Our Ref: 217510_LET_001A

20 May 2020

QUORN PARK SOLAR FARM (SSD 9097)– AMENDMENT REPORT**Construction Water**

PROPOSED CONTROL ROOM BUILDING

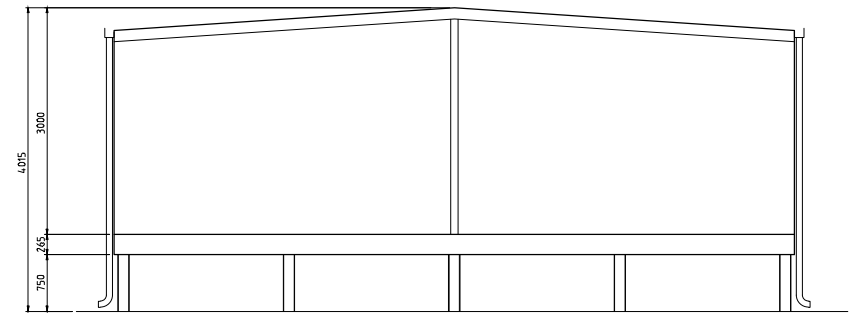
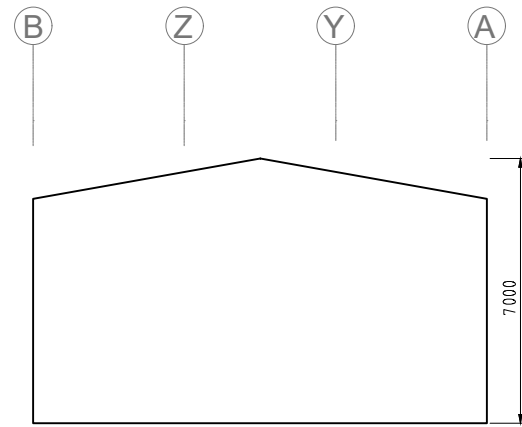
The control room building is now proposed to be 17.5 m wide x 9.0 m deep x 4.5m high. This is a larger building than that identified in the EIS (5 m wide x 3.5 m deep x 2.7 m high). It is also now proposed to include an operations and maintenance shed that would be 18 m wide x 12 m deep x 7 m high. Indicative floor plans and elevations are provided as **Attachment 2**.

Both the control building and operations and maintenance shed would be located within the indicative substation location zone. This location provides for efficiencies in grid connection and centralises infrastructure in the vicinity of the substation compound.

The larger control building and the new operations and maintenance shed will not materially increase impacts on receivers. Both buildings will be constructed using non-reflective finishes and would be located no closer than 1,458 m from any resident.

PROPOSED OPERATIONS AND MAINTENANCE SHED

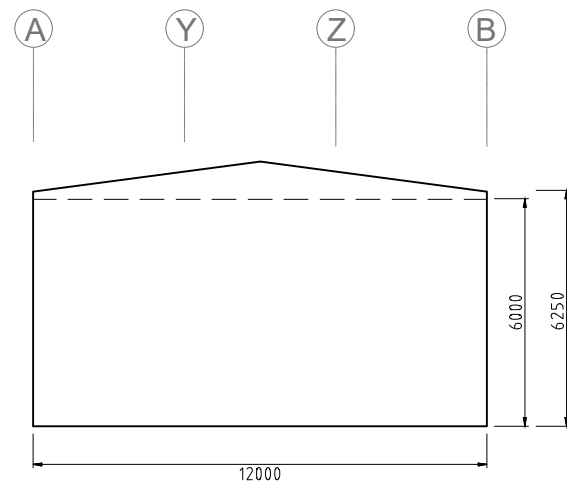
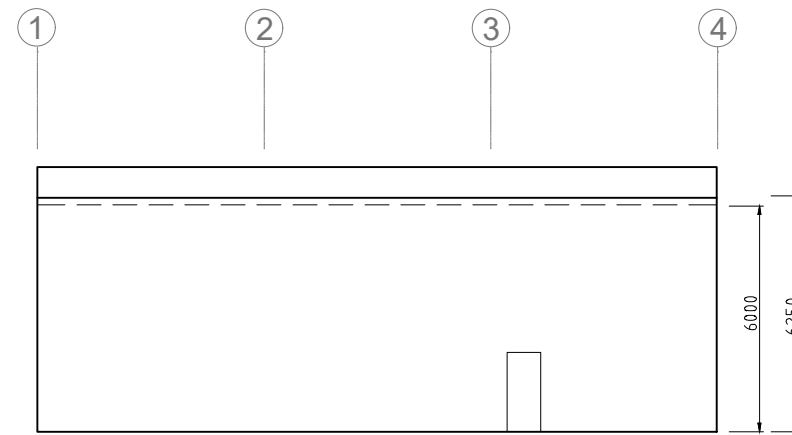
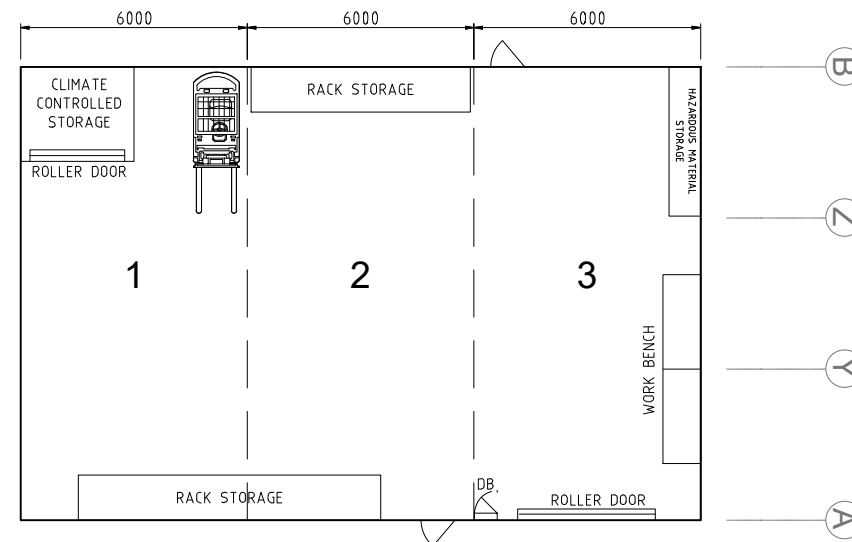
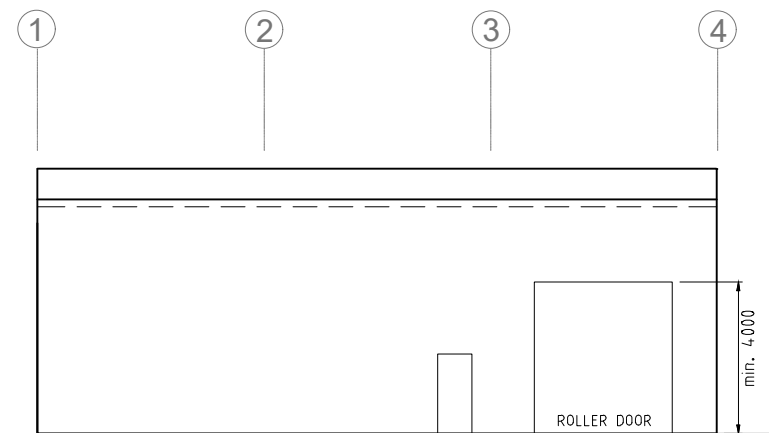
Similarly, the scale and height of the operations and maintenance shed is in keeping with the rural character, noting that sheds of a similar or greater size and height (up to 10 metres in height and 2,000 m² in size) may be constructed in the RU1 zone as exempt development (that is, without recourse to Council or a certifier). This confirms the suitability of these buildings.
